फ़ाइल संख्या: एन.आई.पी.जी.आर./इंजीनियरिंग/5/12/2018-19

CORRIGENDUM

Name of work: Supply, Installation, Testing & Commissioning of High Precision A.C. in Lab 008 for Metabolome Facility at NIPGR Campus, New Delhi.

LAB LAYOUT

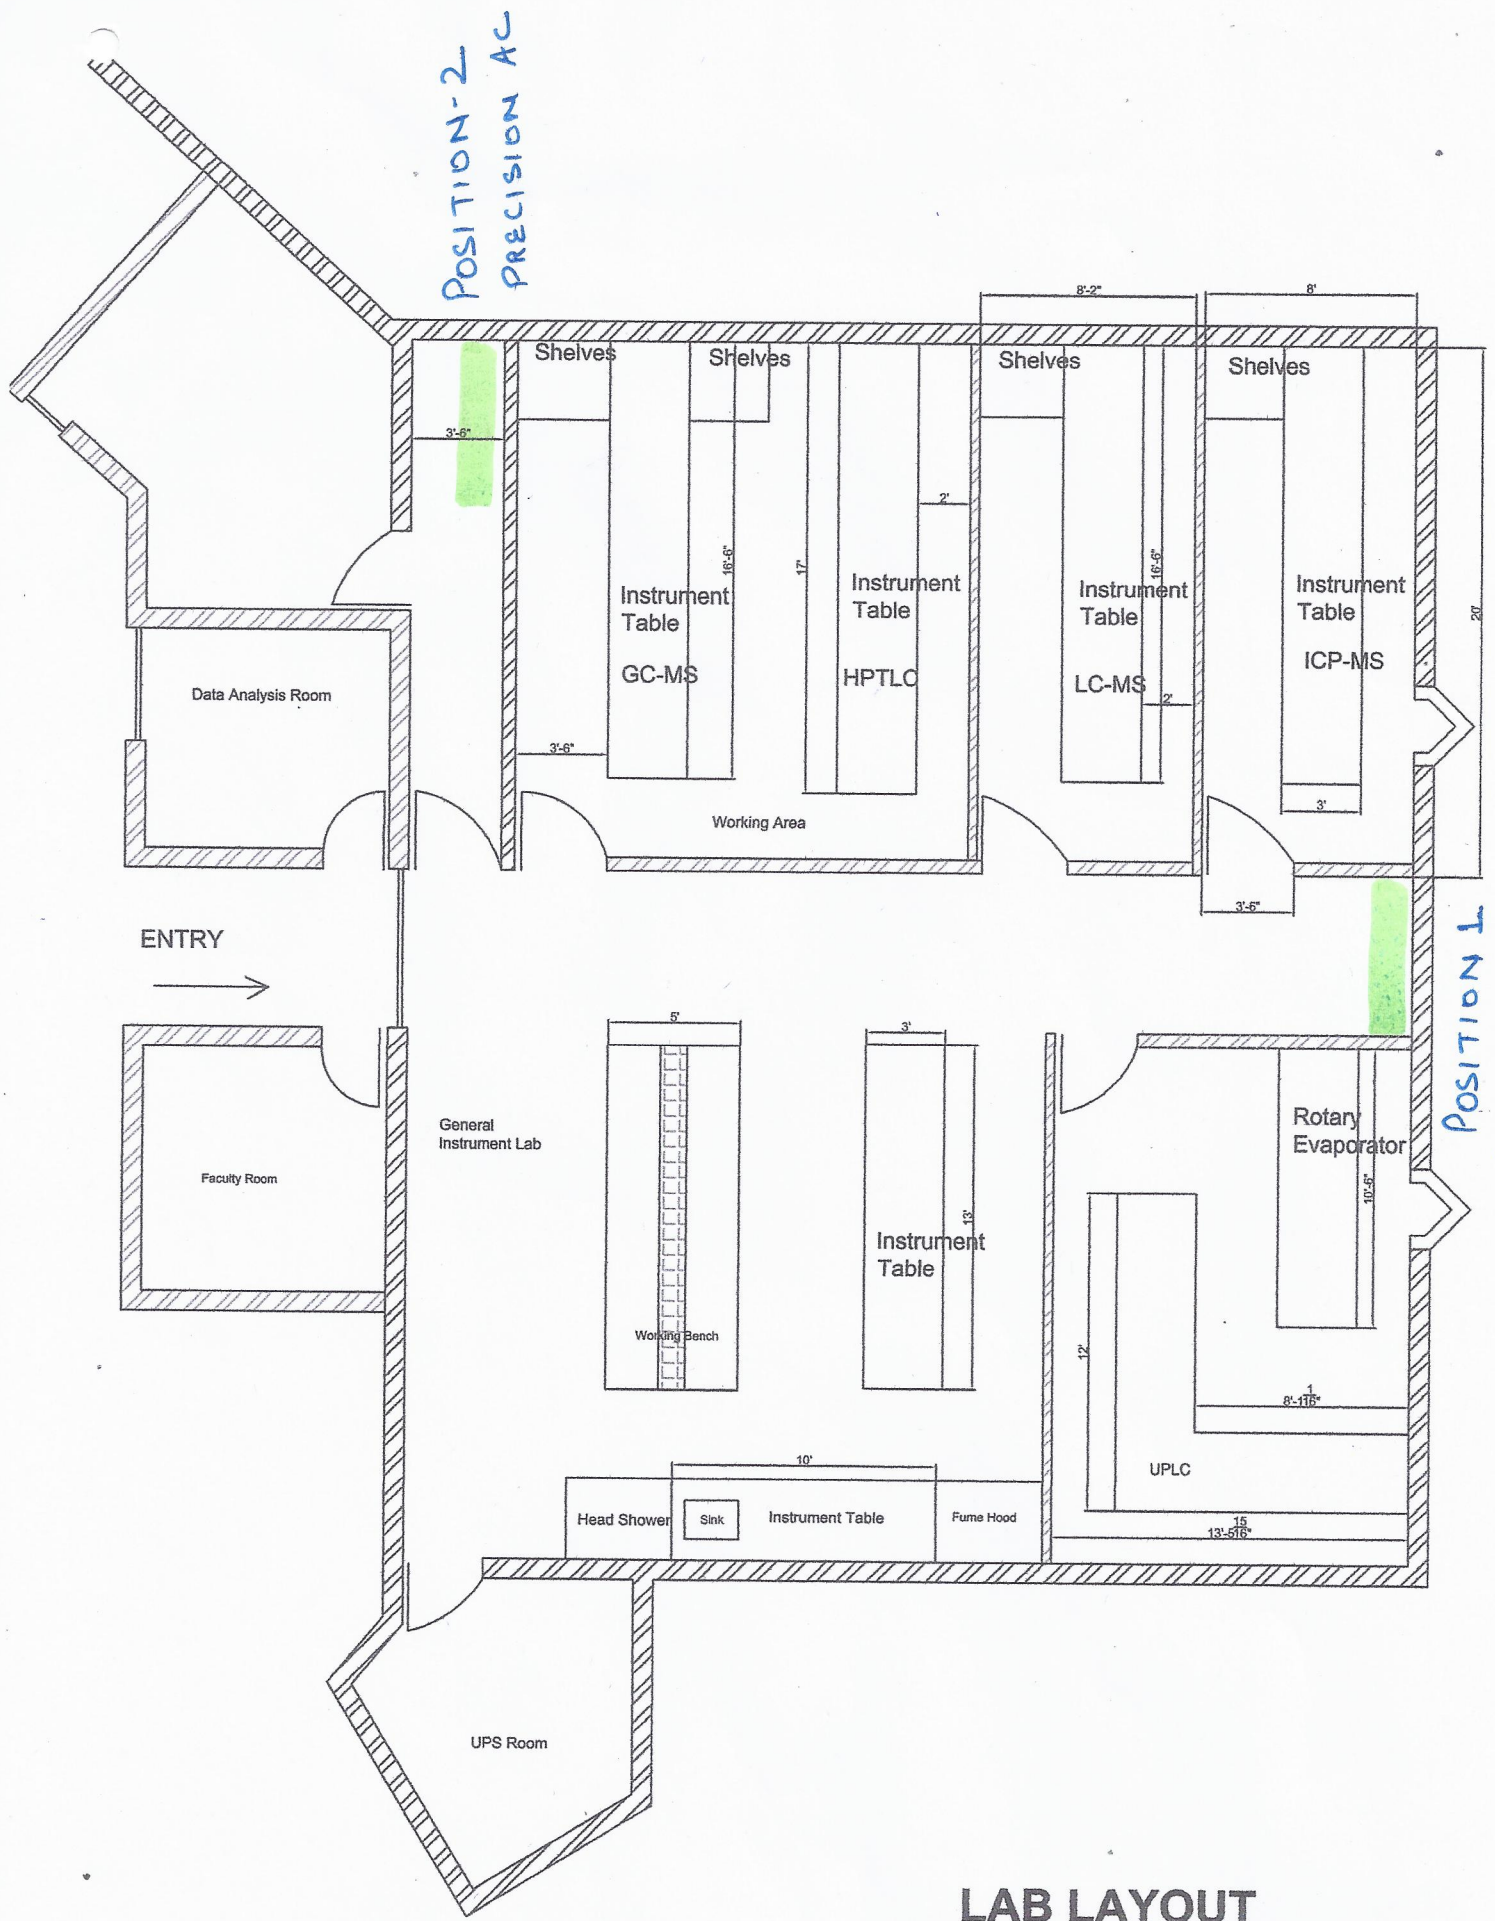
1. Part-A & B High Side work and Low Side work item No. 1 – **High side work includes SITC of High side equipment. Low Side equipment includes low side equipment's along with accessories required to make system functional. Also, no existing machine is to be installed.**
2. The CFM required for 10 TR machine is 5000 to 5500 and The CFM required for 7.7 TR machine is 3500 to 4000.
3. The revised layout of lab is enclosed.
